RE: Caliber Collision – 5900 Washington Street, Hollywood, Florida
General Application – Preliminary Technical Advisory Committee (TAC)

RE: Caliber Collision
5900 Washington Street

We respectfully submit the following responses to your comments:

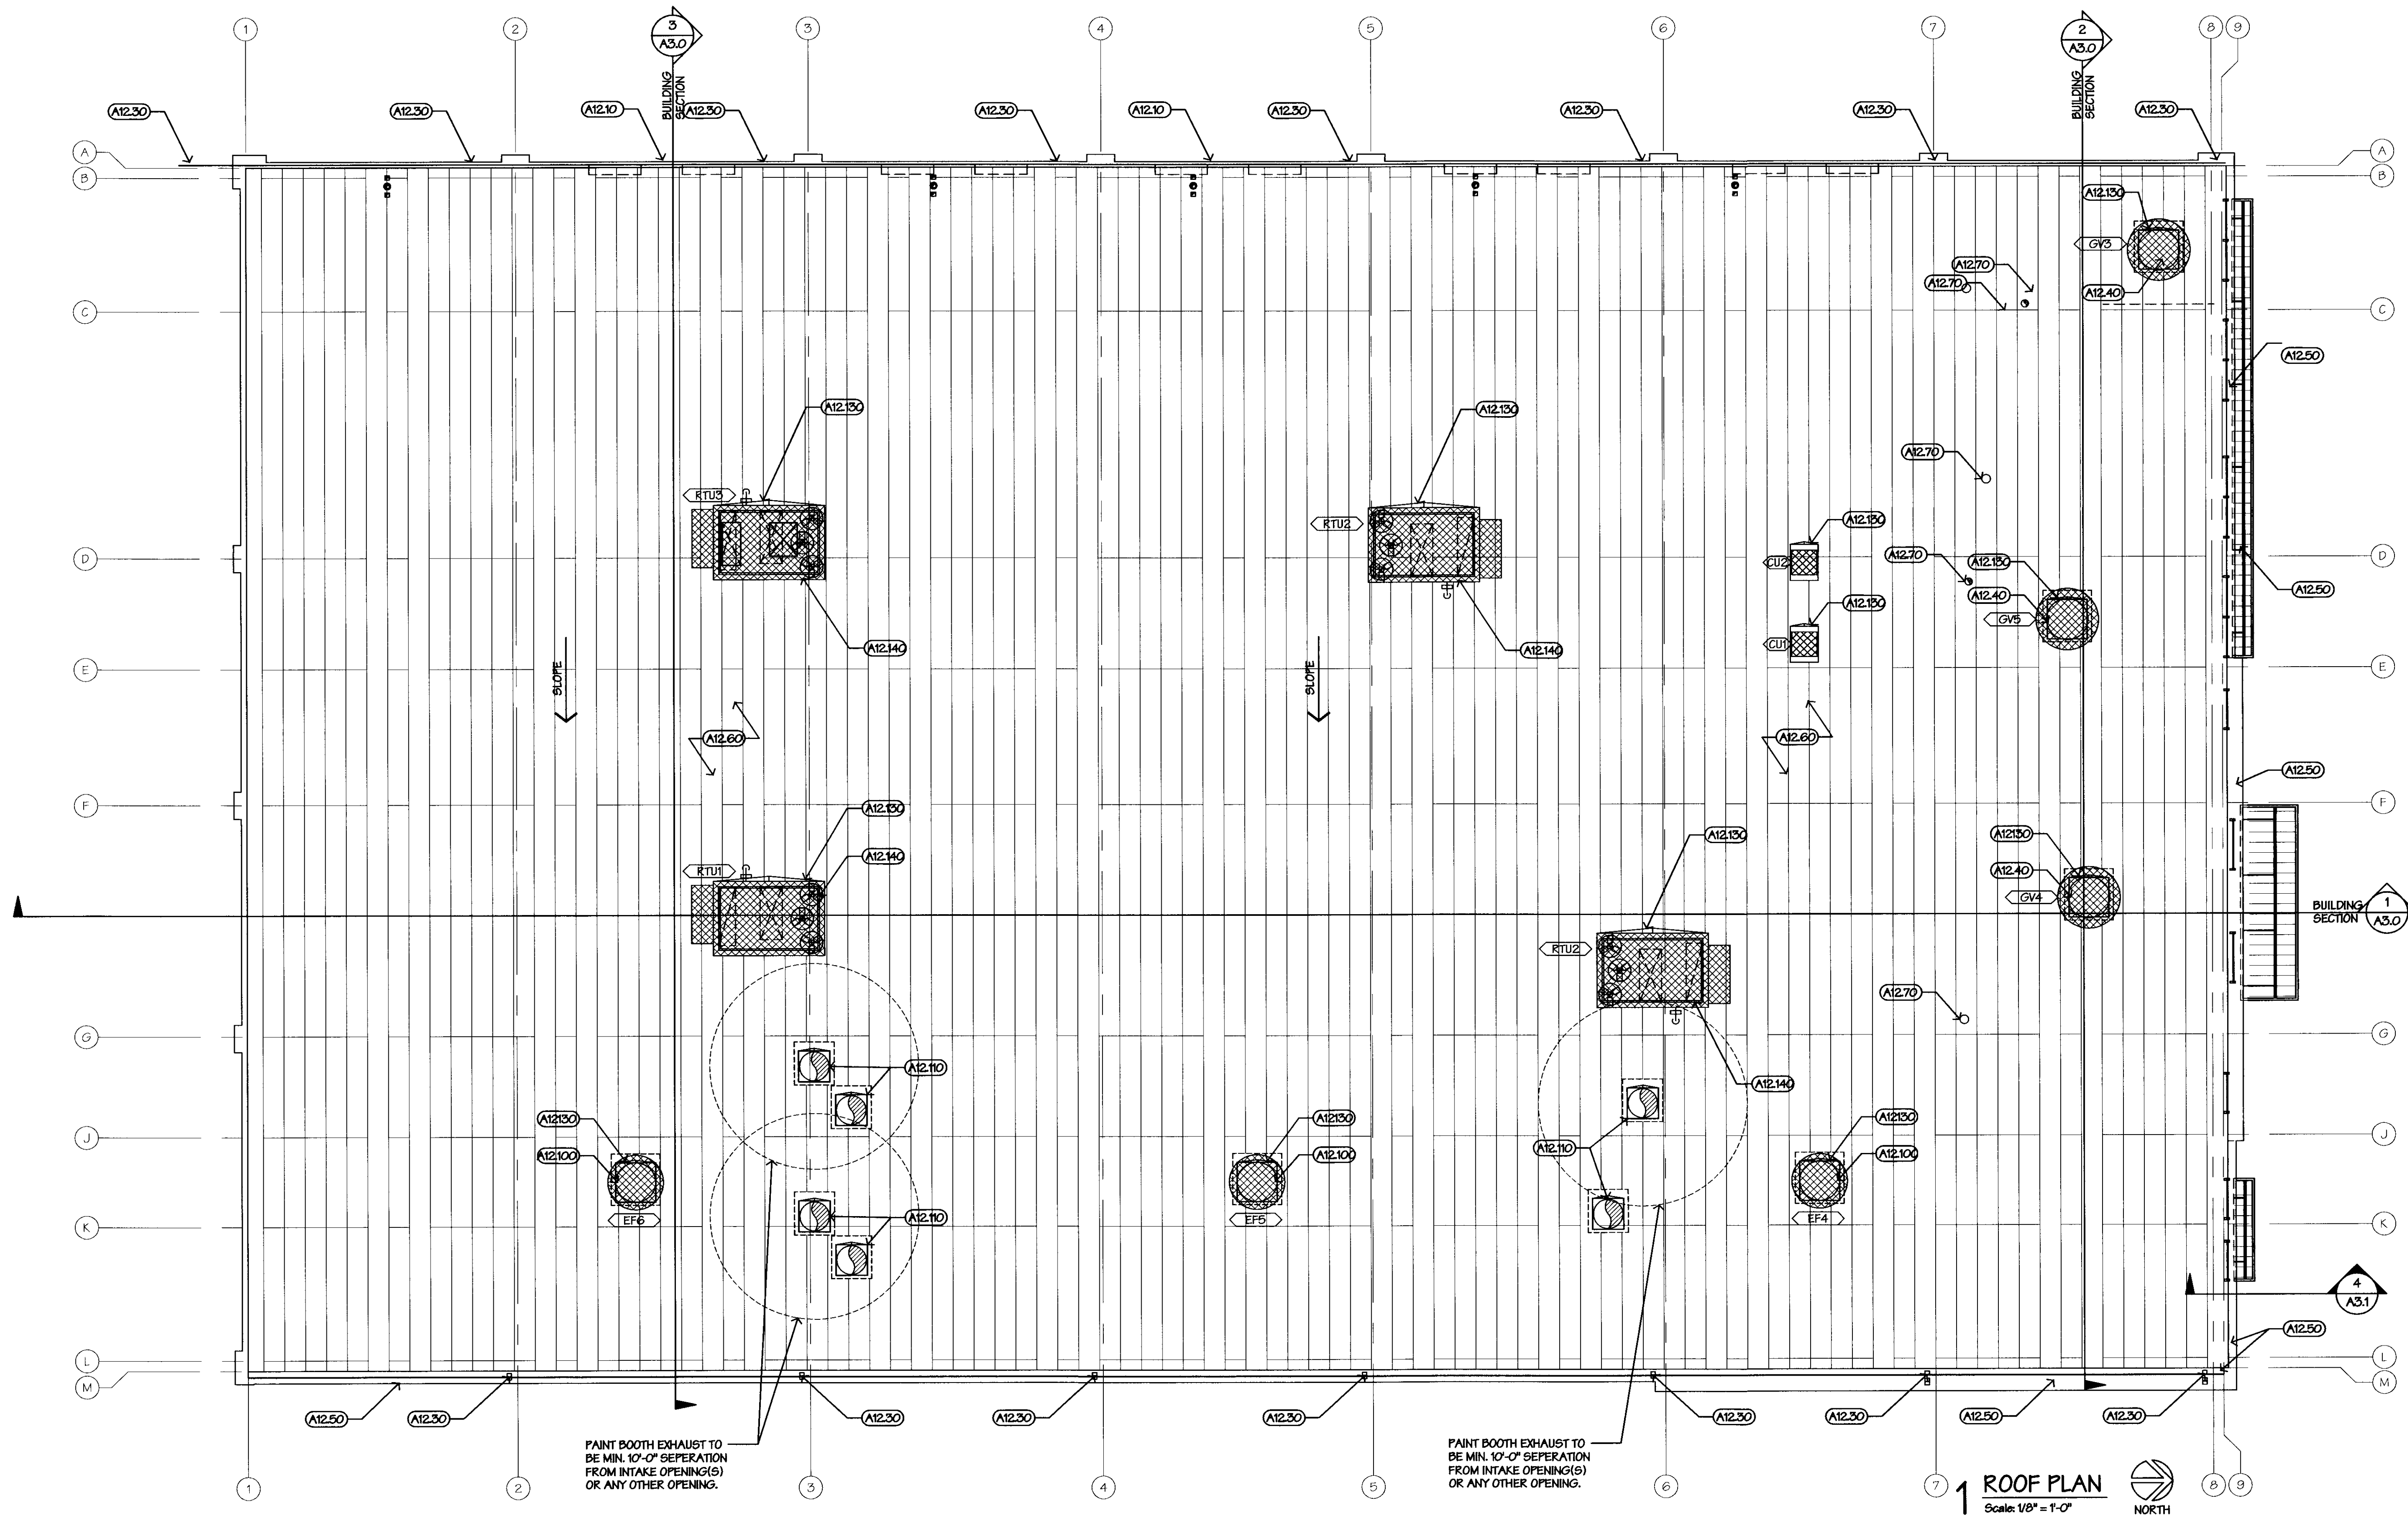
5. No roof plan was included for review

6. Sheet A2.0: What is the “Roof Screen” constructed of?

Response: A roof plan has been provided.

Response: The city was going to require the roof top mechanical equipment, ventilation fans, ventilation intakes, and paint booth duct terminations to be screened. The screening on the roof was going to be very complex and chopped up. We have elected to extend the fascias to screen the roof top equipment. This should be much better looking and offer fewer roof penetrations which will make for a much tighter roof.
